ADDENDUM NO. 1

August 21, 2018

**MAISON DE LA FRANCOPHONIE D'OTTAWA
2720 Richmond Road, Ottawa, Ontario**

The following is provided to bidders as additional information and/or clarification and/or in response to questions.

M-100	0
-------	---

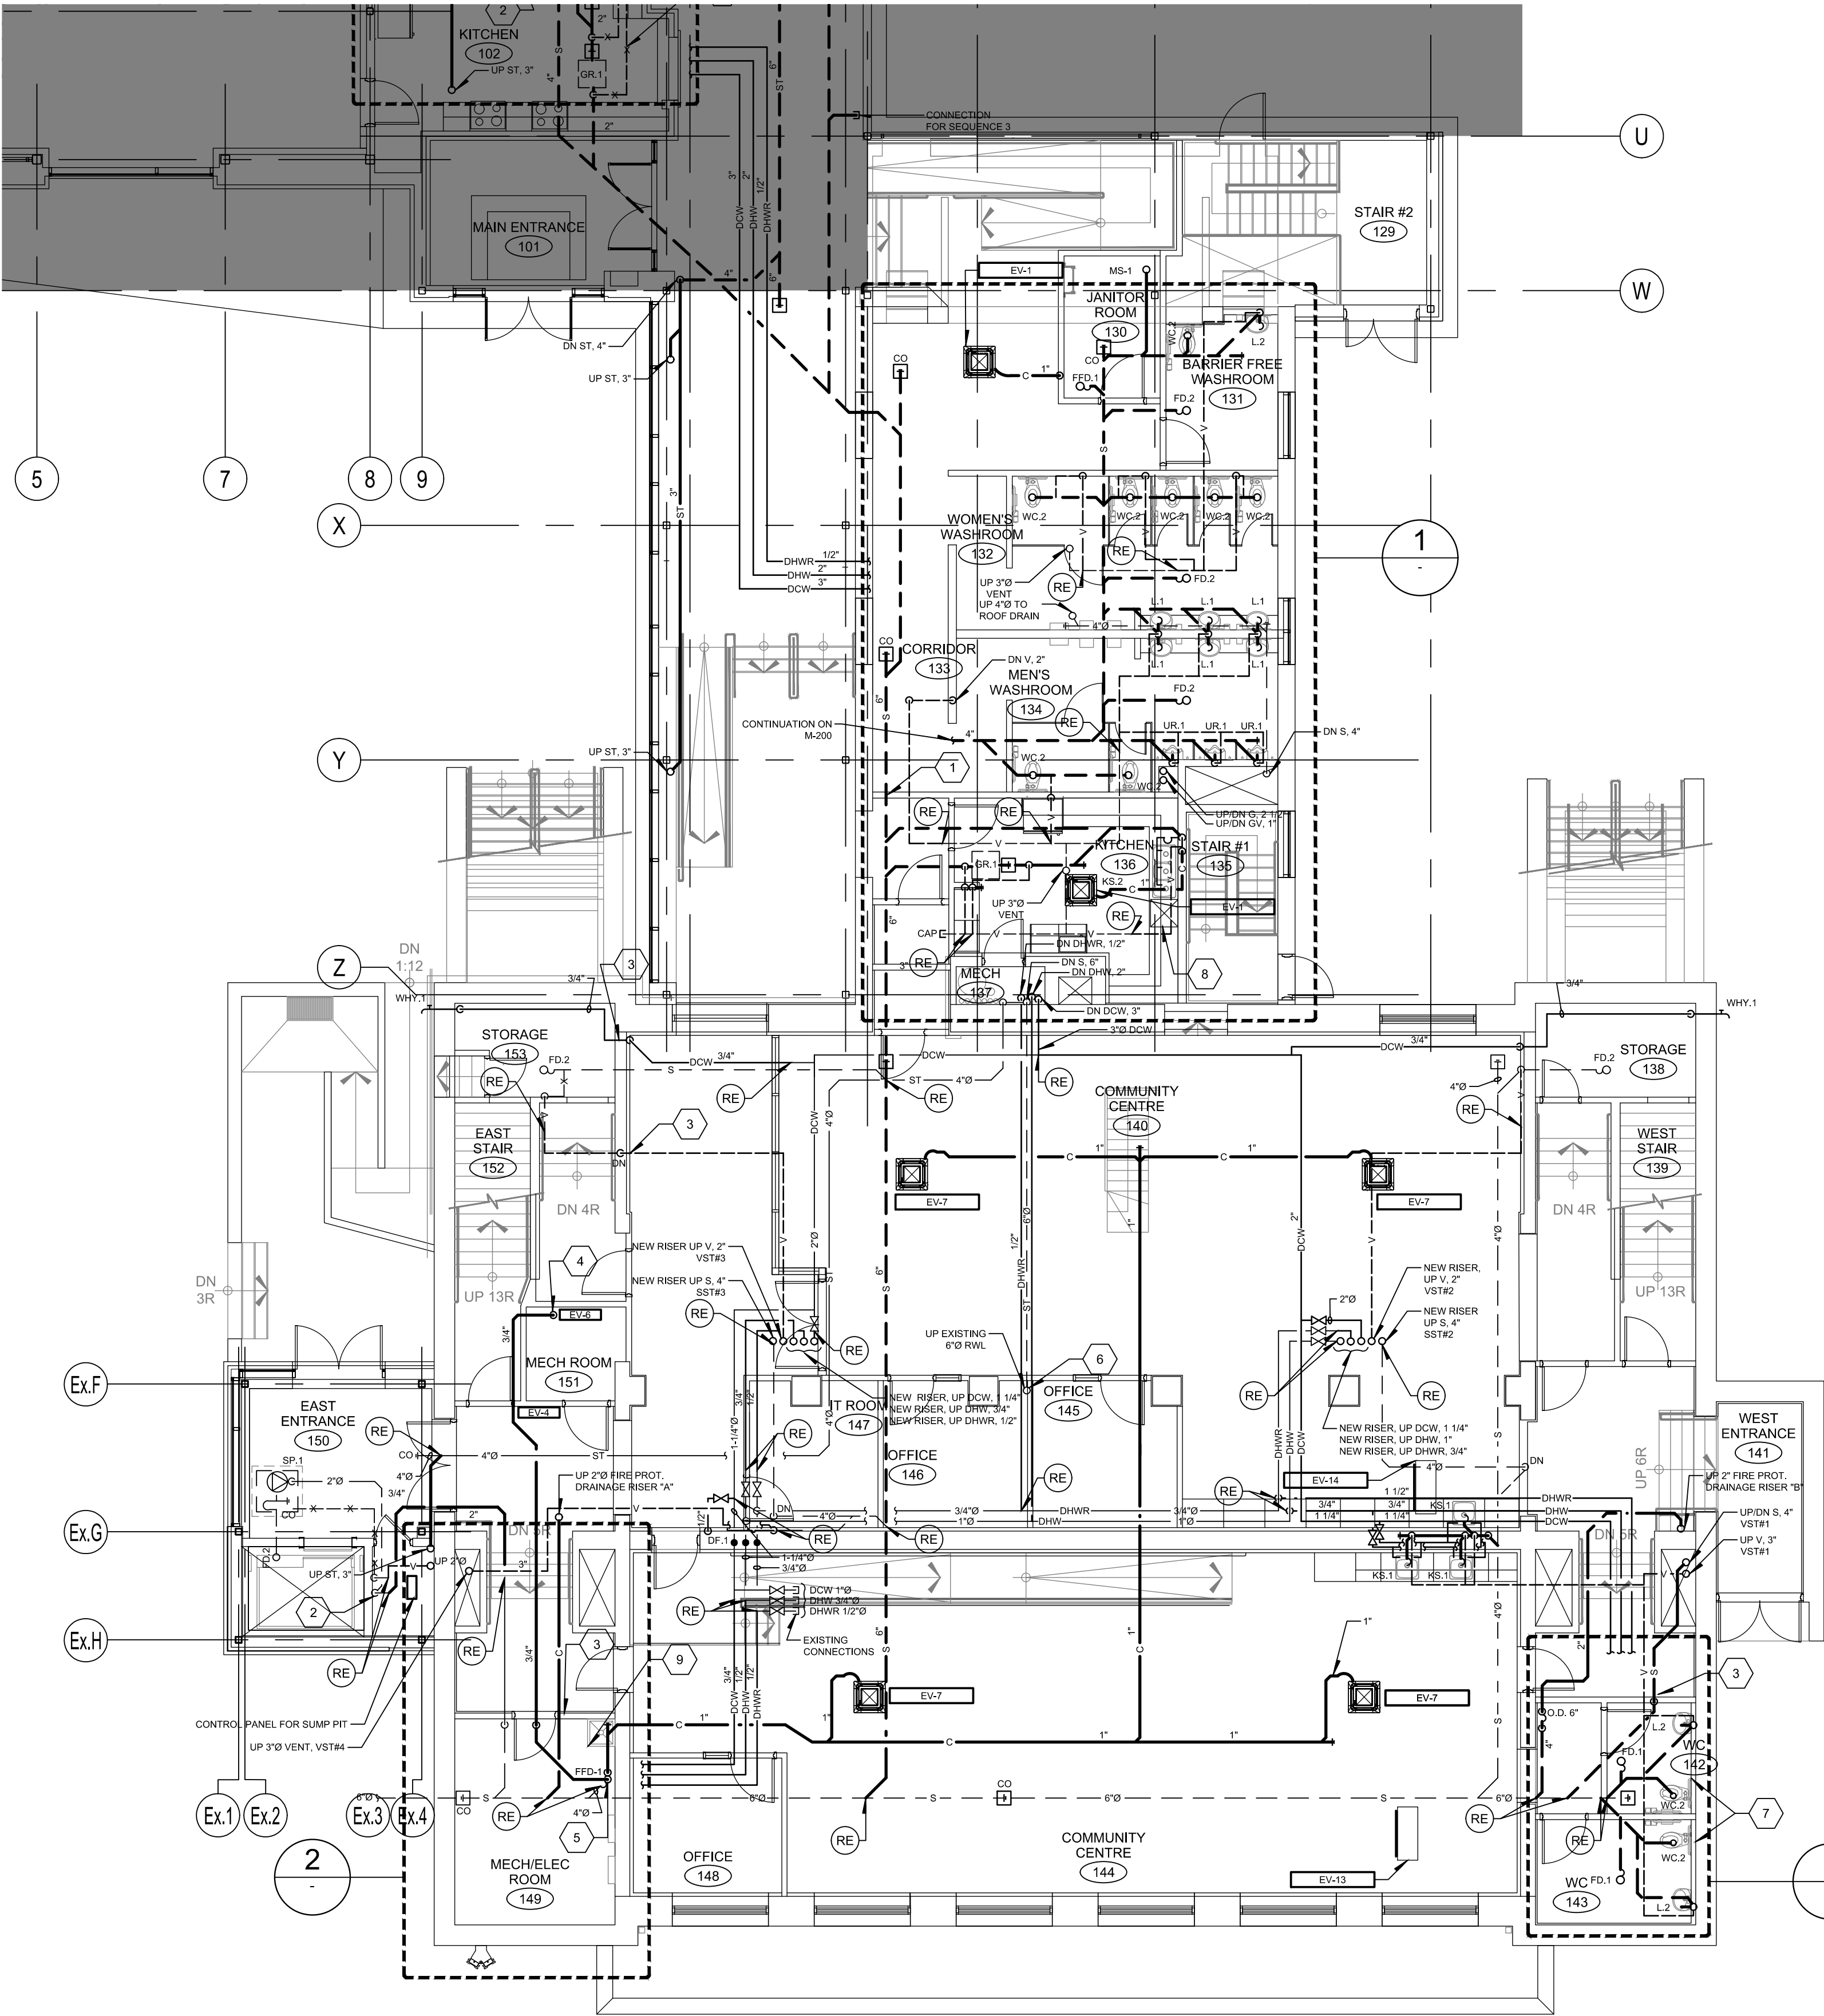
- A1.4** **Q:** Drawing M-100 is missing/not included. It is noted on the cover page, but not within the combined drawing document (175 pages).

A: Drawings M-100 is missing from the package, please find attached drawing to be added to contract.

M-201

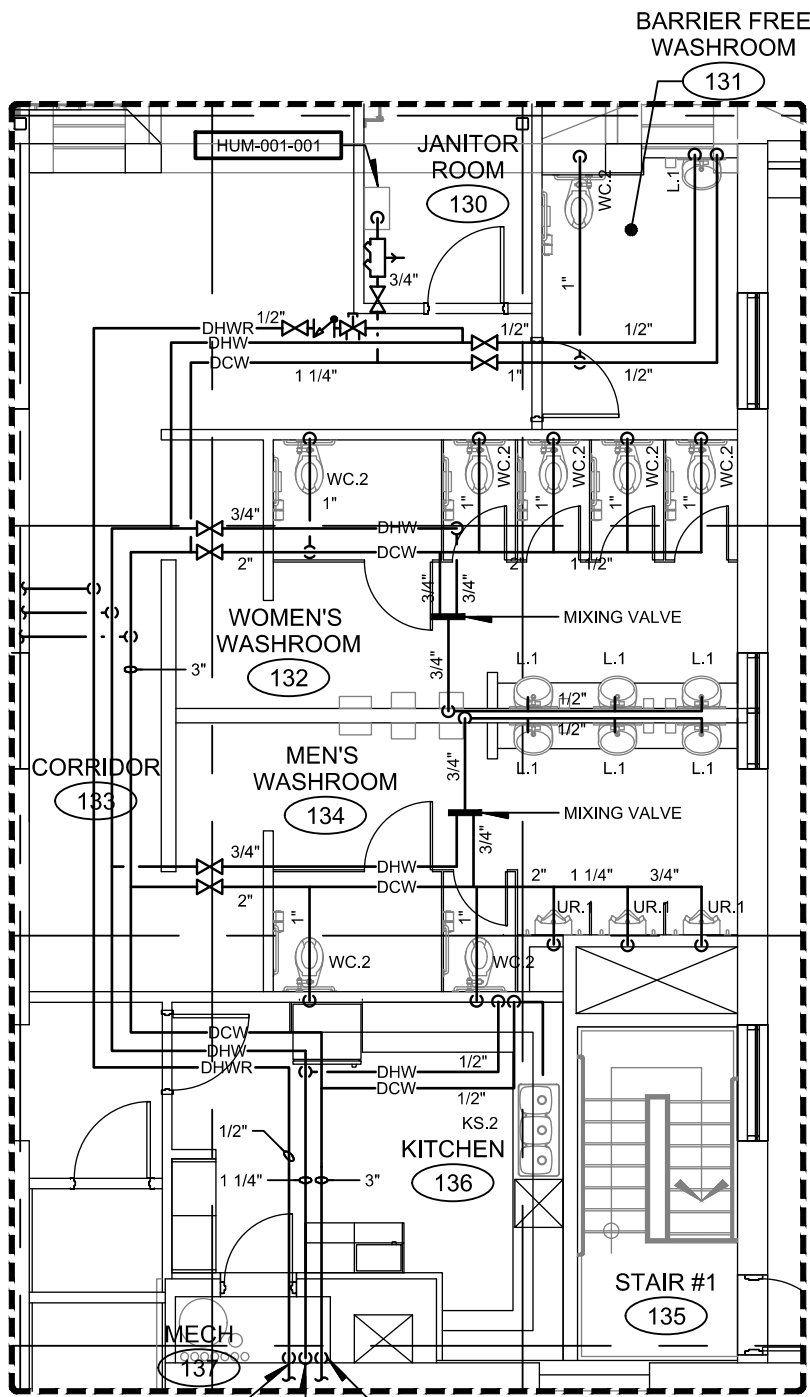
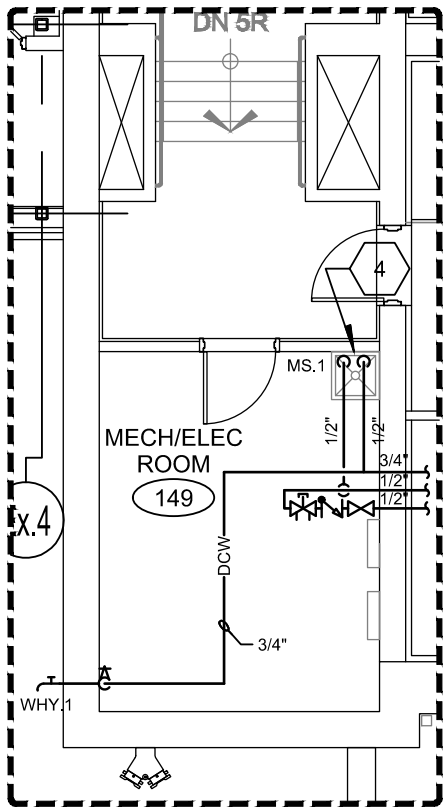
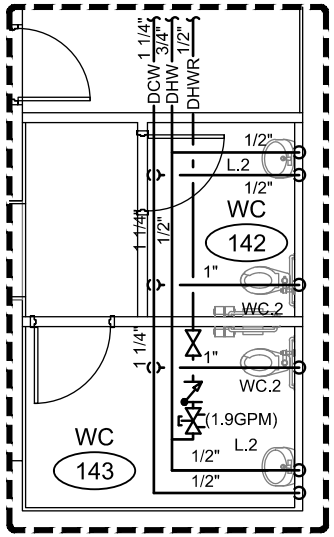
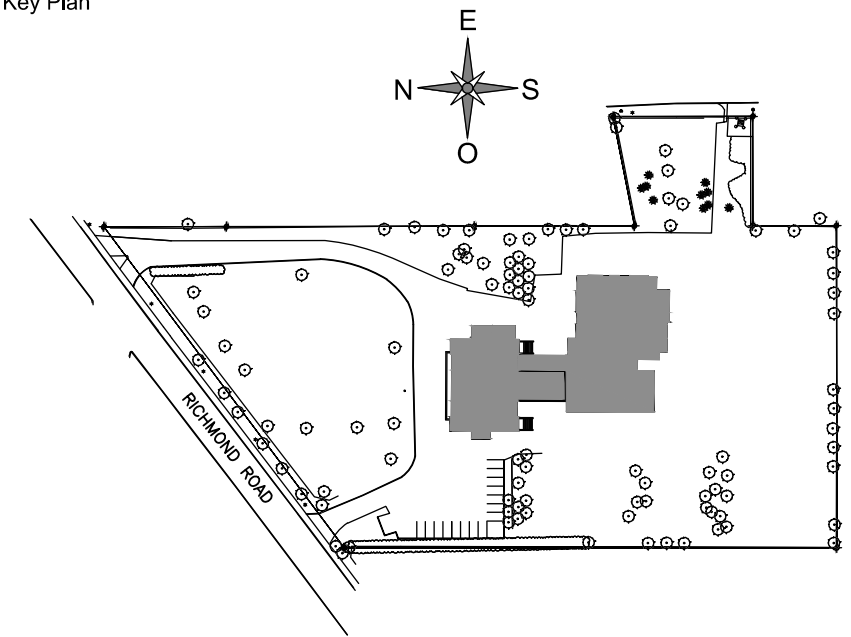
- A1.5** **Q:** Two drawings are labelled M-201, they are similar, but slightly different. Please confirm if one required a different label, or if one supersede the other.

A: Please remove (2) drawings labelled as M-201 and replace with attached M-201.
